UNITED STATES PATENT AND TRADEMARK OFFICE

APPLICATION NO.	FILING DATE	FIRST NAMED INVENTOR	ATTORNEY DOCKET NO.	CONFIRMATION NO.
09/929,350	08/15/2001	Jerome M. Eldridge	M4065.0454/P454	8862
24998	7590	09/10/2004	EXAMINER	
DICKSTEIN SHAPIRO MORIN & OSHINSKY LLP			CHU, CHRIS C	
2101 L STREET NW			ART UNIT	PAPER NUMBER
WASHINGTON, DC 20037-1526			2815

Office Action Summary	Application No. <u>09/929,350</u>	Applicant(s) ELDRIDGE ET AL.	
	Examiner Chris C. Chu	Art Unit 2815

DETAILED ACTION

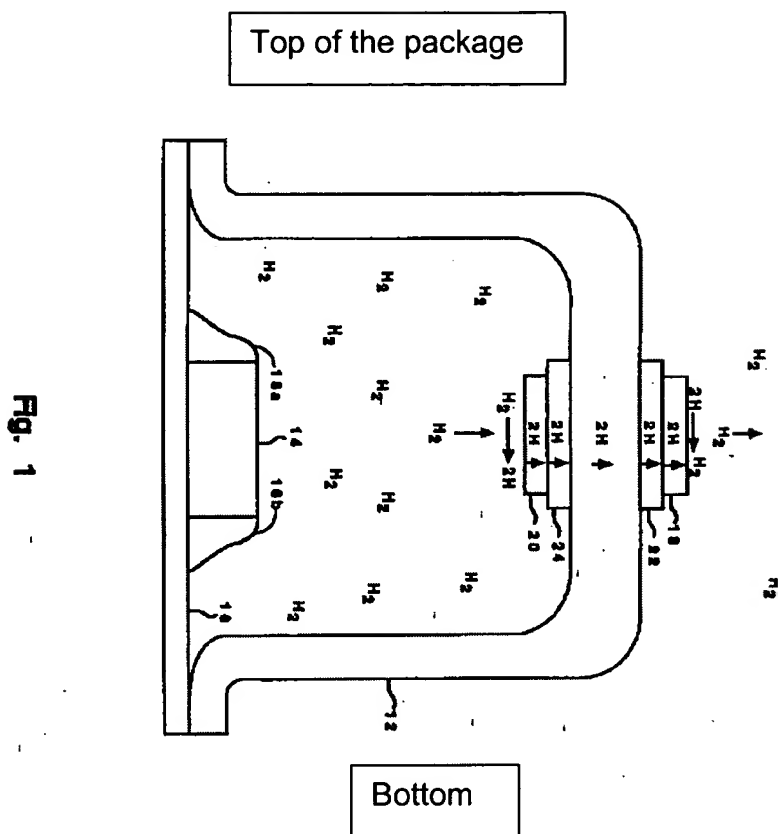
- a thin layer (16a) deposited over at least part of or partially covering said semiconductor chip (at the side view point of Fig. 1; see figure in page 13 of this Office action) comprising a source of releasable hydrogen (column 5, lines 1 - 10) within said enclosure.

On page 38, applicant argues "Stupian does not teach the limitations of claim 37 or claim 88. Claims 37 and 88 recite 'a thin layer deposited over at least part of said semiconductor chip comprising a source of releasable hydrogen within said enclosure.' ... claims 37 and 88 is 'deposited over at least part of said semiconductor chip,' not on the wall of the package." This argument is not persuasive. Stupian clearly shows in Fig. 1 that the thin layer (16a) deposited over at least part of said semiconductor chip (14).
